# Access Compliance Report

## Public Rights-of-Way

### (Curb Ramps)

Intersection ID: 10019157	Main Street: TIPPAH_PARK_CT	Cross Street: N/A	Location: N
ADA ID: 80F0F91A982A	Ramp Type: Perp	Initial Pass/Fail: Fail	Overall Compliance: No
			Severity Score: 26.25

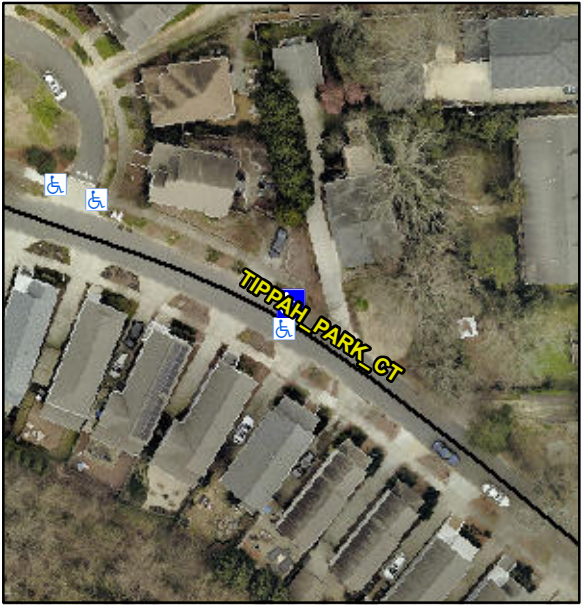
Codes/Mitigation Info/Possible Solution			Field Measurements/Component Compliance		
	Possible Solutions:		<b>Compliance</b>	<b>Description</b>	<b>Data</b>
	Remove & Replace Entire Ramp.		N/A	Ramp Length (in)	70.0
			Yes	Ramp Width (in)	59.0
			N/A	Flare Type LT	N/A
			N/A	Flare Slope LT (%)	N/A
			N/A	Flare Traversable LT?	N/A
			N/A	Landing Length (in)	N/A
			N/A	Landing Width (in)	N/A
			N/A	Landing Slope (%)	N/A
			N/A	Landing X Slope (%)	N/A
<p>Surveyor Notes:</p> <p>N/A</p> <p>PROW/ADA:</p> <p>R304.2.2, R304.5.3</p>			N/A	Flare Type RT	N/A
			N/A	Flare Slope RT (%)	N/A
			N/A	Flare Traversable RT?	N/A
			N/A	DWS Provided?	N/A
			N/A	DWS Contrast?	N/A
			N/A	DWS Length (in)	N/A
			N/A	DWS Full Width?	N/A
			N/A	DWS Offset (in)	N/A
			N/A	Shared Landing?	N/A
			N/A	Gutter Ponding?	N/A
			N/A	Gutter Lip Ht (in)	N/A
			N/A	Painted X Walk1?	No
				X Walk 1 Direction	To SW
			N/A	X Walk 1 Width (in)	N/A
				X Walk 1 Slope (%)	0.8

X Walk 1 X Slope (%)	1.1
			N/A	Ramp inside XWalk1?	N/A
			N/A	Road Slope (%)	N/A
			N/A	Road X Slope (%)	N/A
			N/A	Any Obstructions?	N/A
				Obstruction Type	
Total Cost:		\$ 1850.00			
			N/A		N/A
			Yes	Surface Condition? (G/P)	Good
